# CITY OF ALBUQUERQUE

**Re: First Nations Community Healthsource, Building C, BP-2019-31804**  
**5608 Zuni Road SE, 87108**  
**30-Day Temporary Certificate of Occupancy**  
**Transportation Development Final Inspection**  
Engineer's/Architect's Stamp dated 7-28-17 (L18D047)  
Certification dated 04-25-19

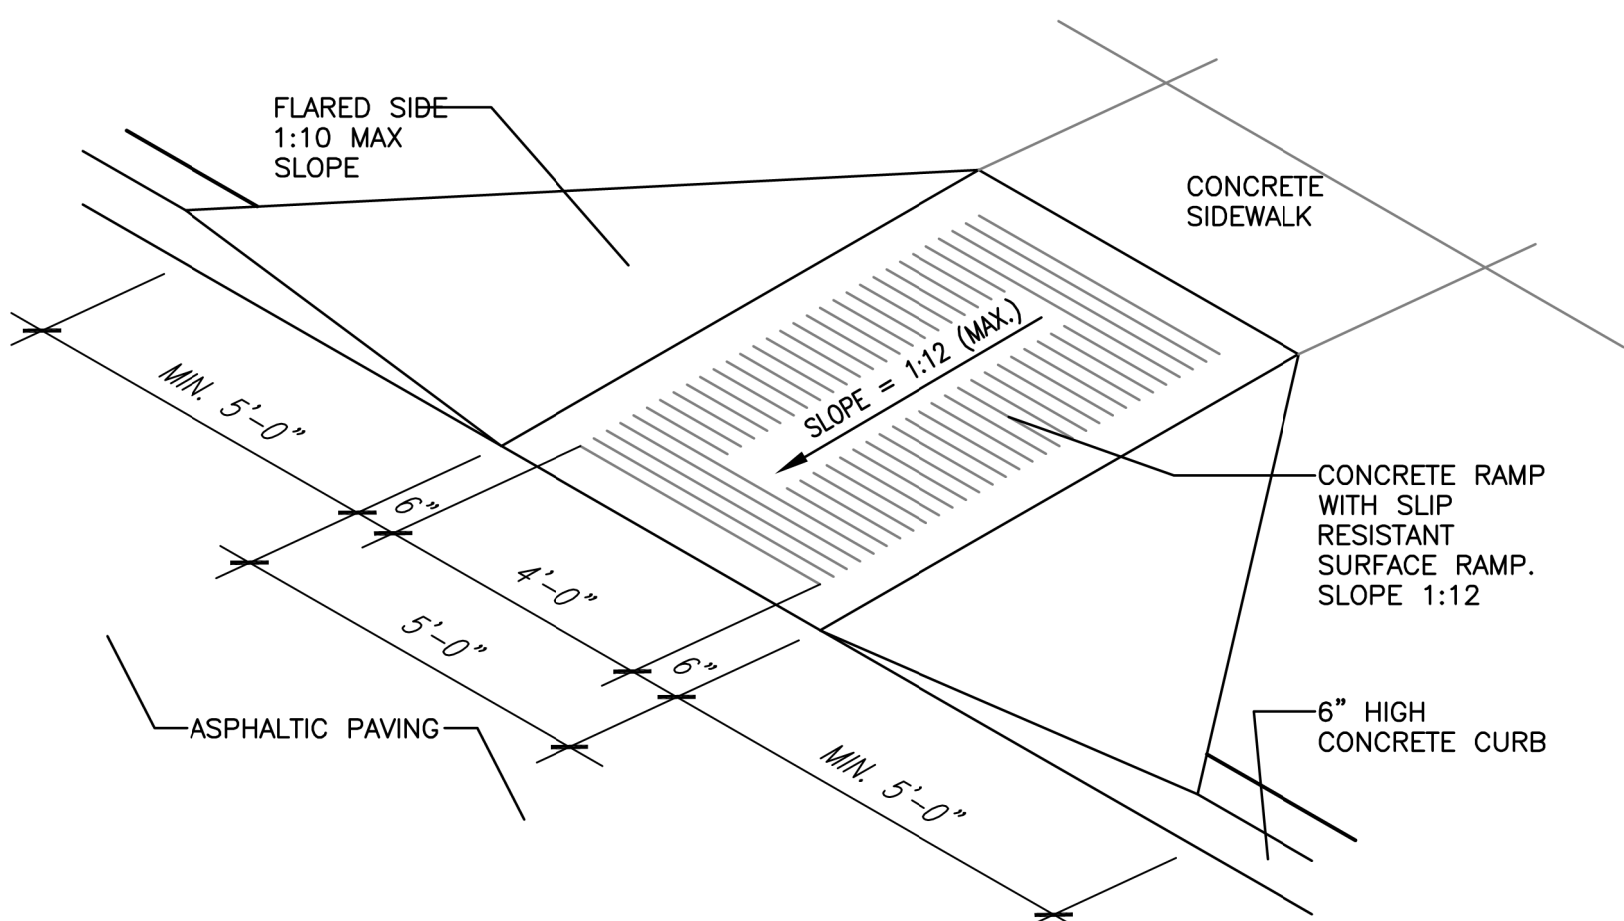
1. Please widen ADA walk path even with wheel stop.  
(See attached photo)  
Measurement taken at site measured @ 3 foot 6 inches.

A1 ARCHITECTURAL SITE PLAN

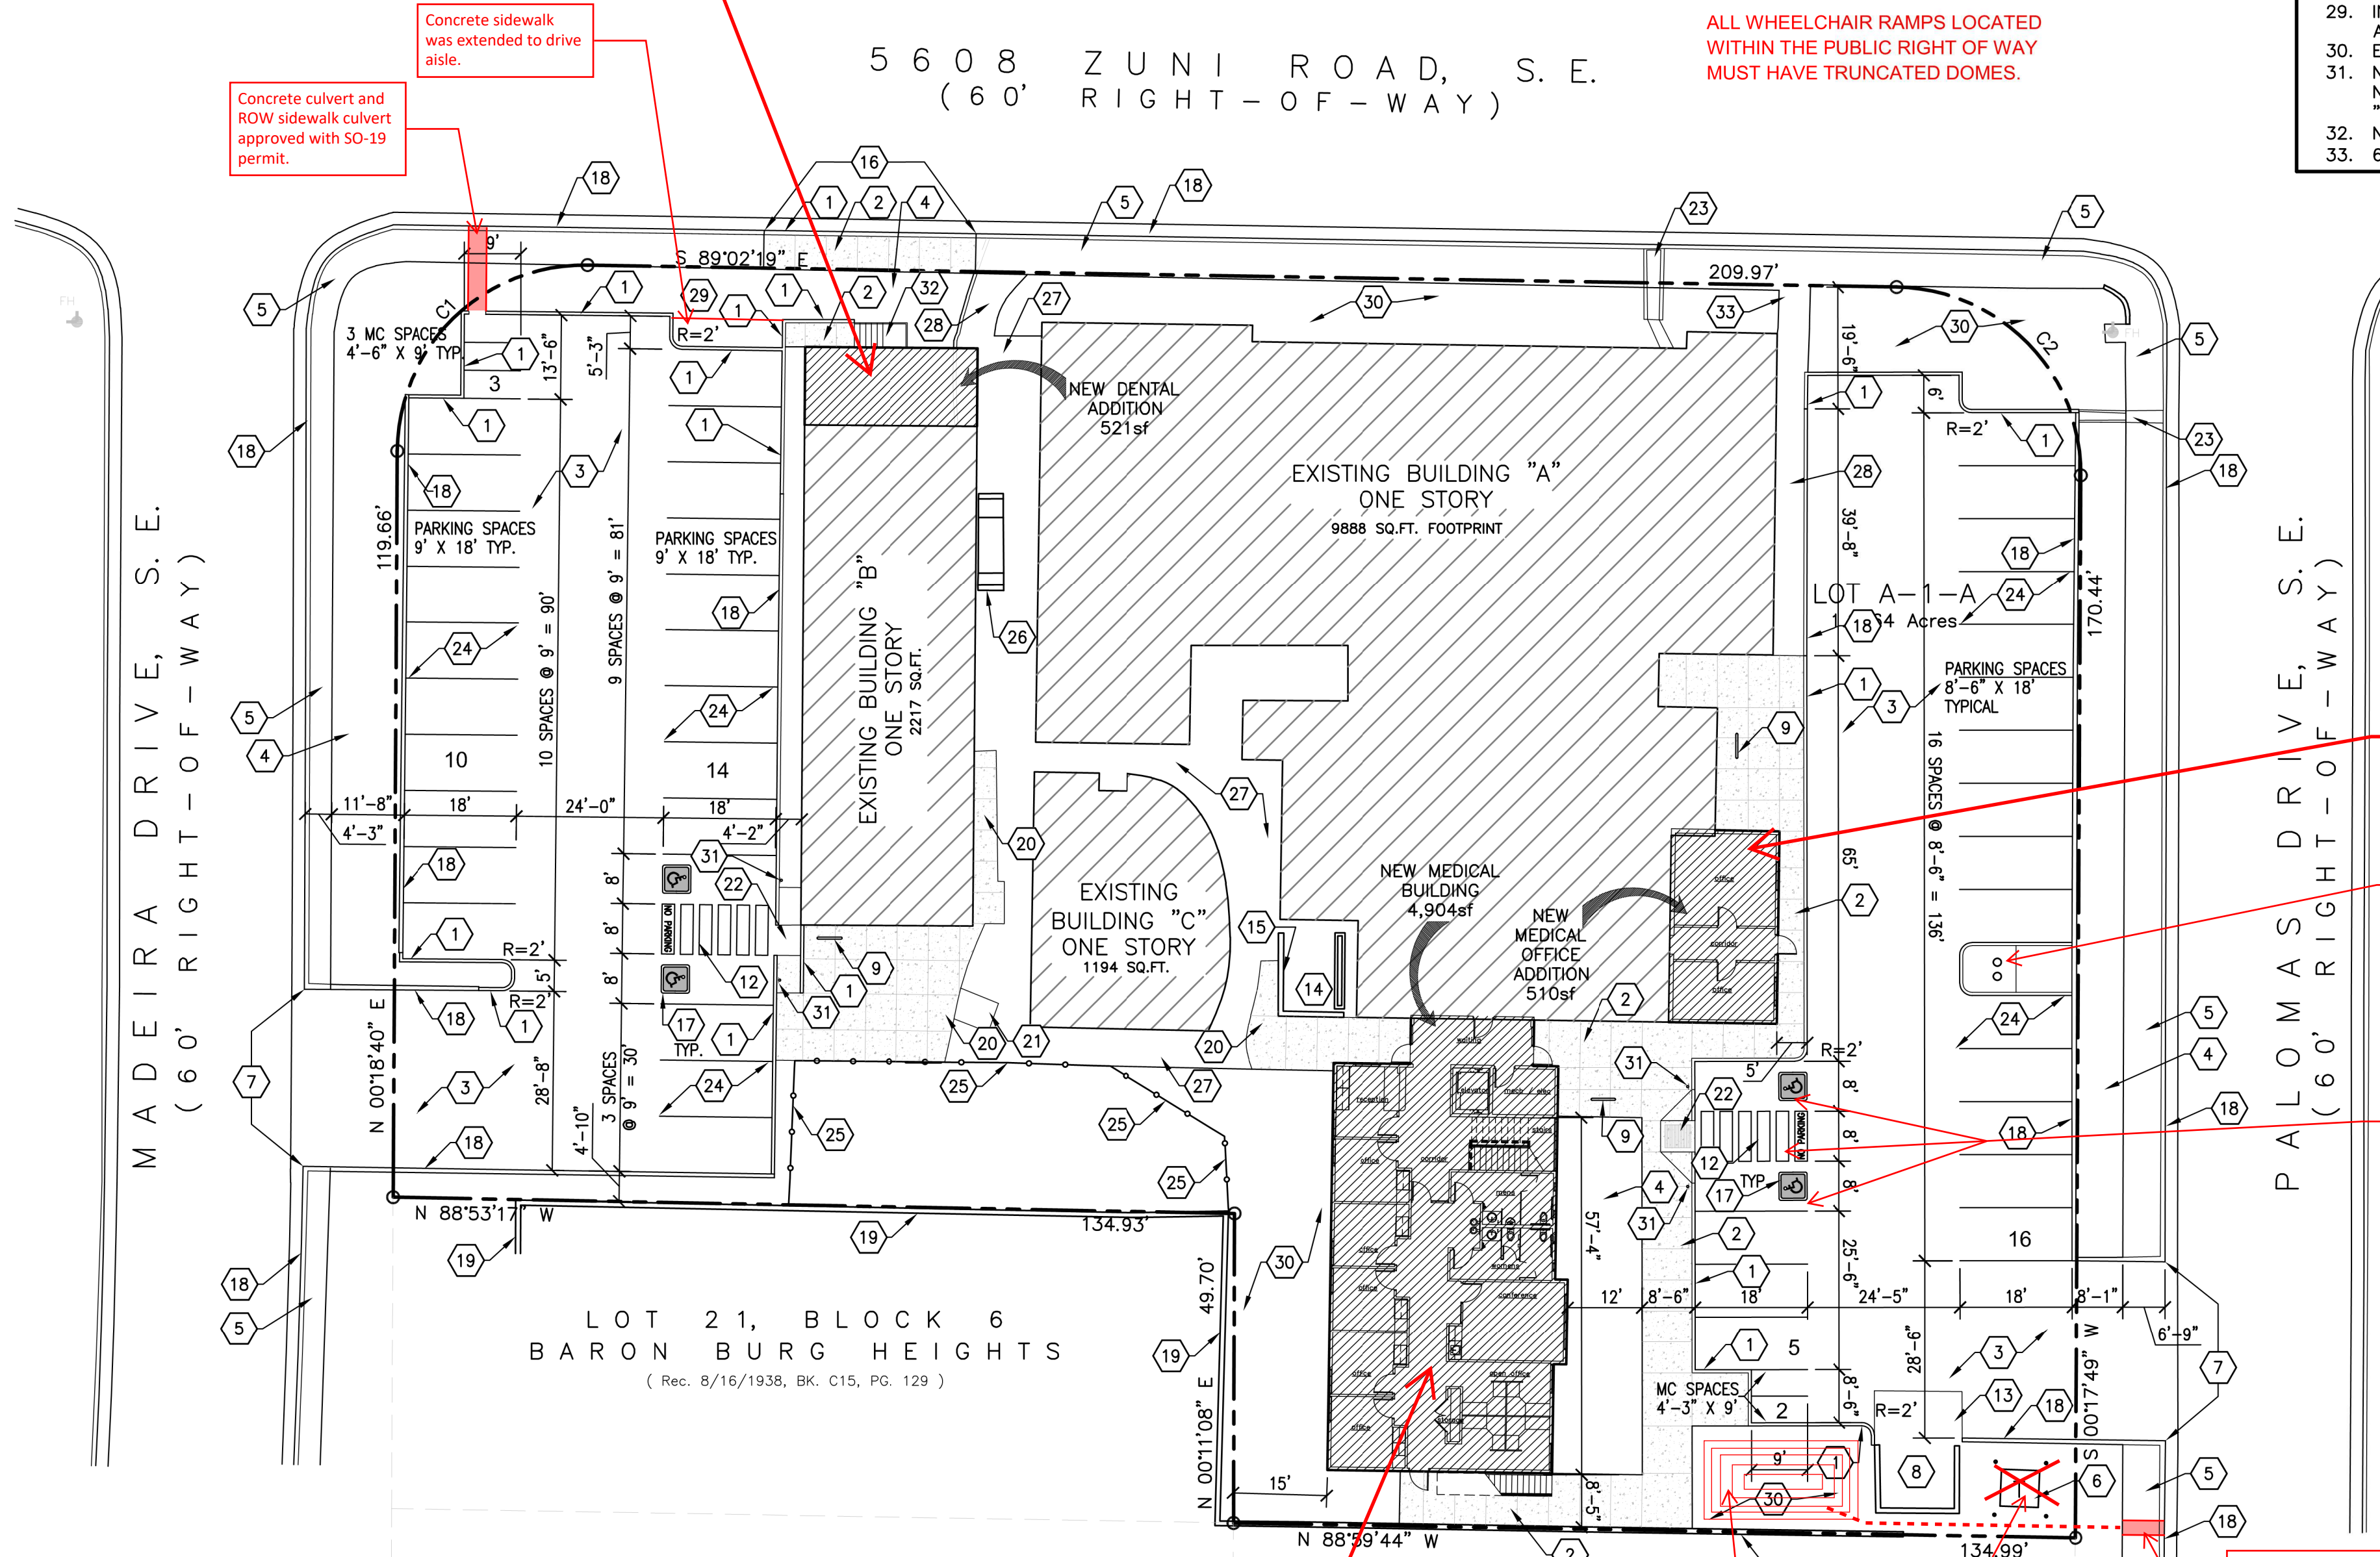
Removed island as building did not  
need sprinklers/ FDC. Additional  
parking space was added.

HC parking spaces and aisle was  
moved one parking spaces south.  
See picture below.

Electrical Transformer  
was not relocated.

Below grade  
overflow drainage  
pipe and ROW  
sidewalk culvert  
approved with SO-19  
permit.

CUT  
SECTION TO  
WIDEN  
NOT  
PATH

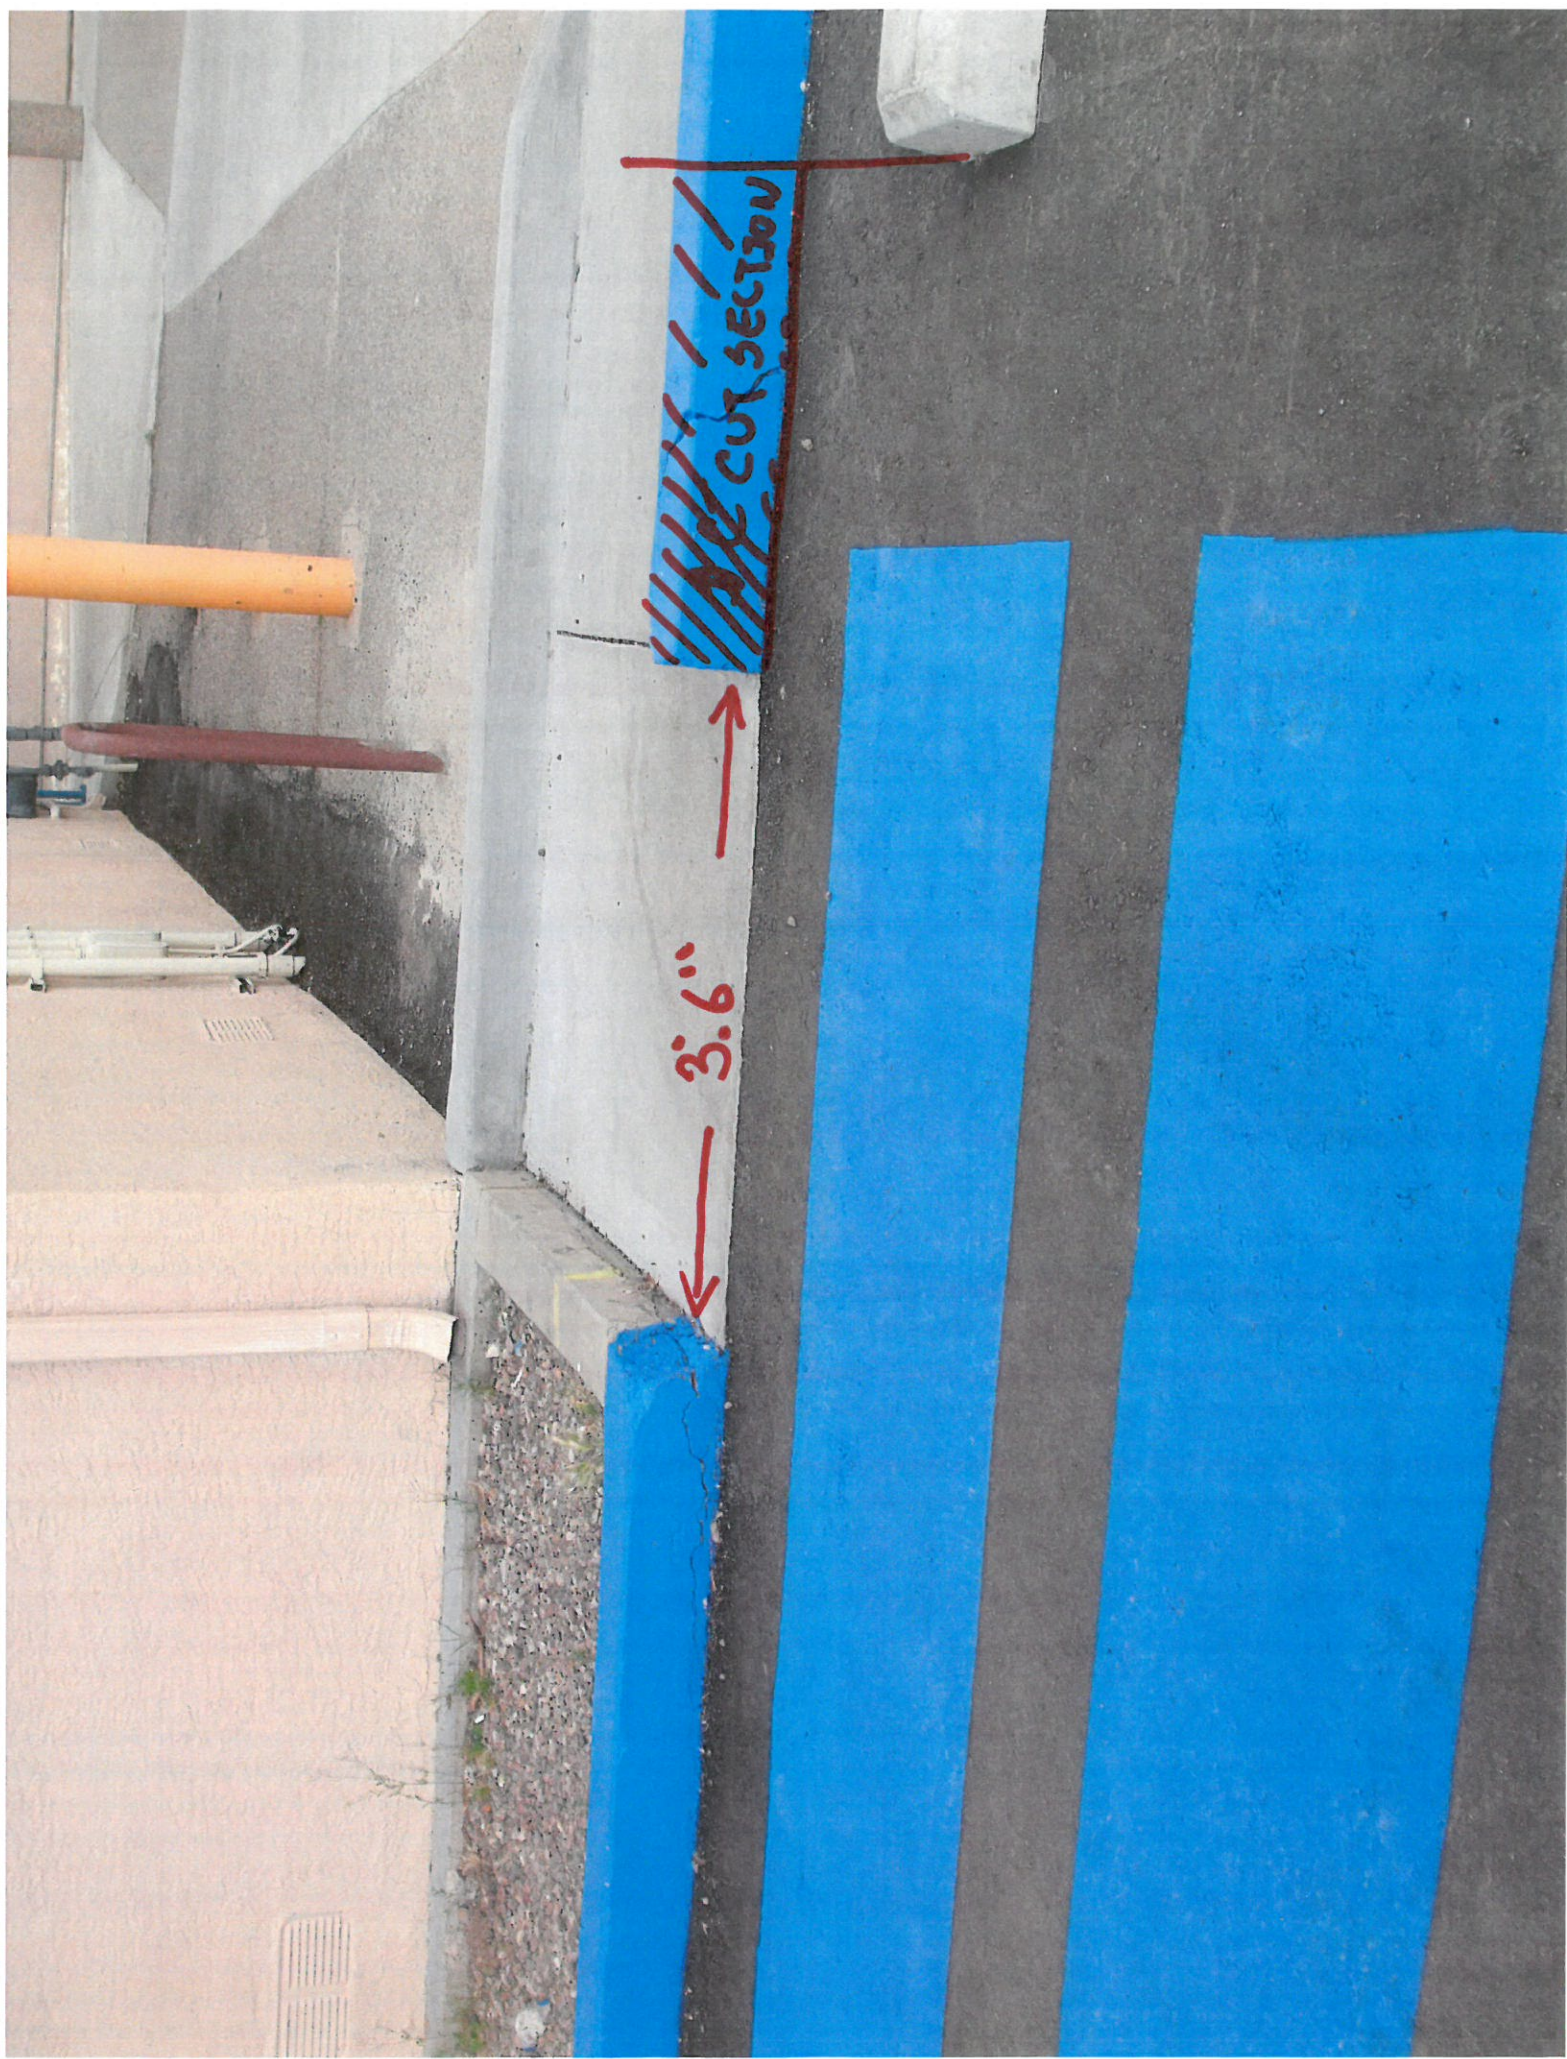
3.6"

CUT SECTION
